I. RF Circuit Changes

Minor changes were made in the RF Circuit to improve tuning. Component changes were as follows:

Schematics depicting these changes are as follows:

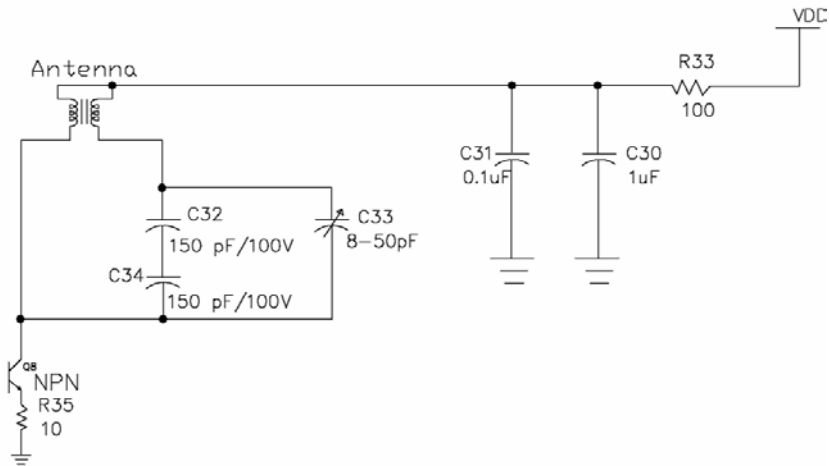
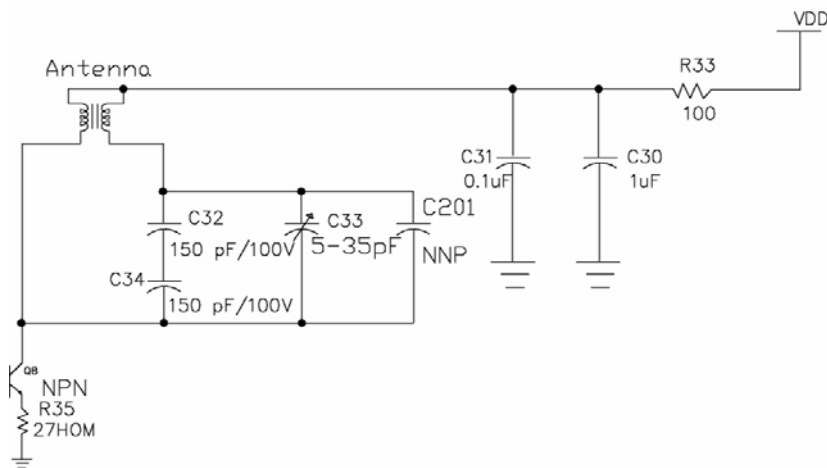
1. Change the resistor R35 from 10 ohm to 27 ohm.
2. Change the trimmer C33 from 8-50pF to 5-35pF.
3. Add the capacitor C201 for tuning.
